**Subject:** 110/230V Autoswitch PCB, part number 1415492  
**Number:** 170  
**Date:** 28<sup>th</sup> July 2000  
**From:** Group Service Manager

# SERVICE BULLETIN

# Autoswitch 110/230V PCB Operation (Tradesarc Dual 141i & Tradestig Dual 151i)

# Autoswitch 110/230V PCB Operation (Tradestarc Dual 141i & Tradestig Dual 151i)

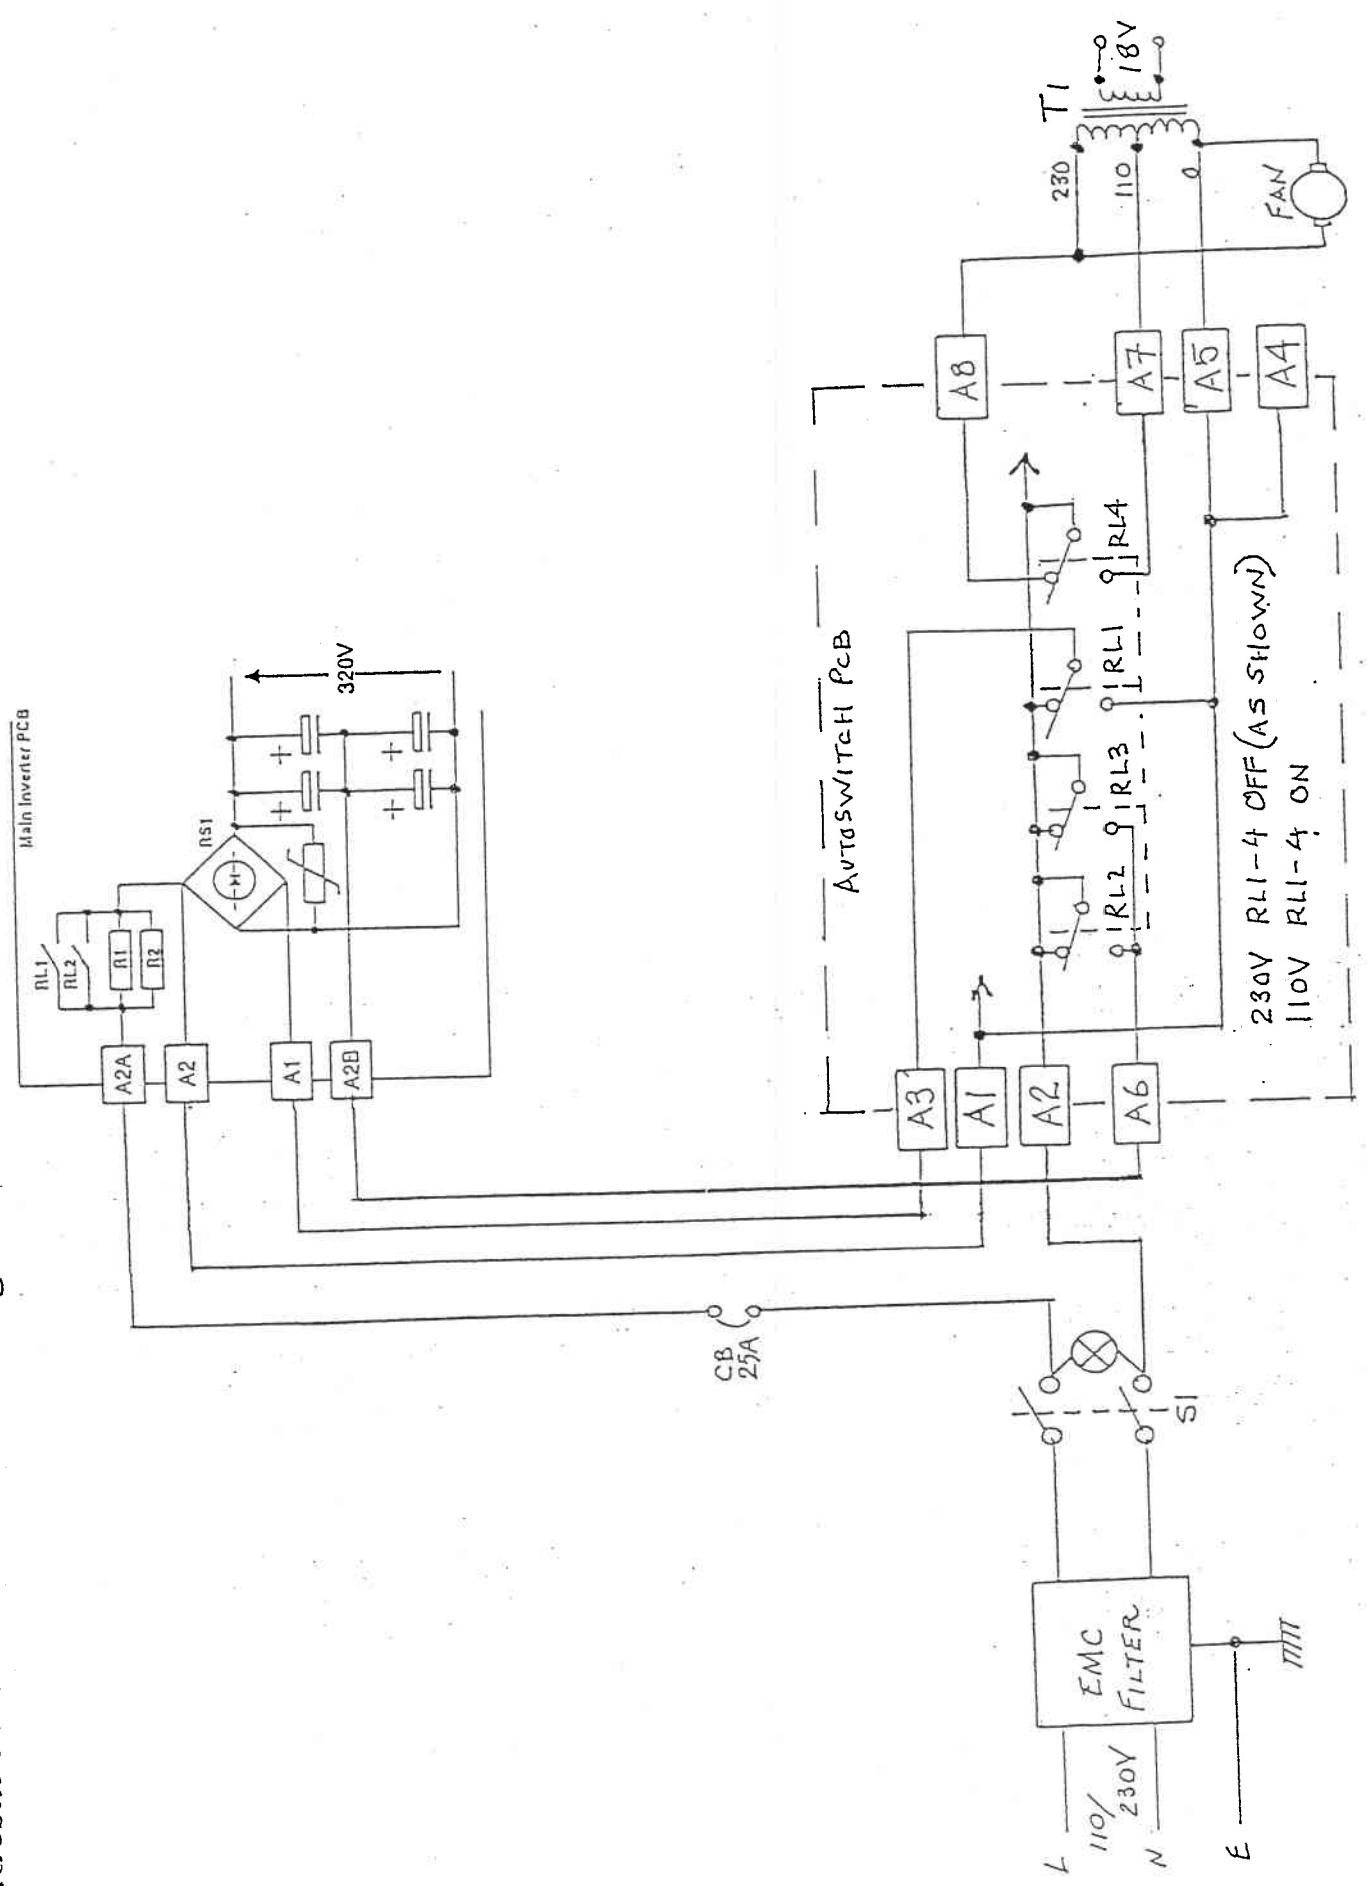
The respective service manuals you were sent contain an incorrect drawing regarding the wiring to this PCB.

The drawing concerned is page 7 in the Tradesarc Dual 141i service manual and page 10 in the Tradestig Dual 151i service manual.

If the unit is wired up as shown on the incorrect drawing the Inverter PCB will be damaged immediately the machine is connected to mains voltage.

**Therefore please find attached the correct drawings, one for each service manual.**

Therefore please ensure that all your engineers are made aware of the above and that all incorrect drawings are destroyed.
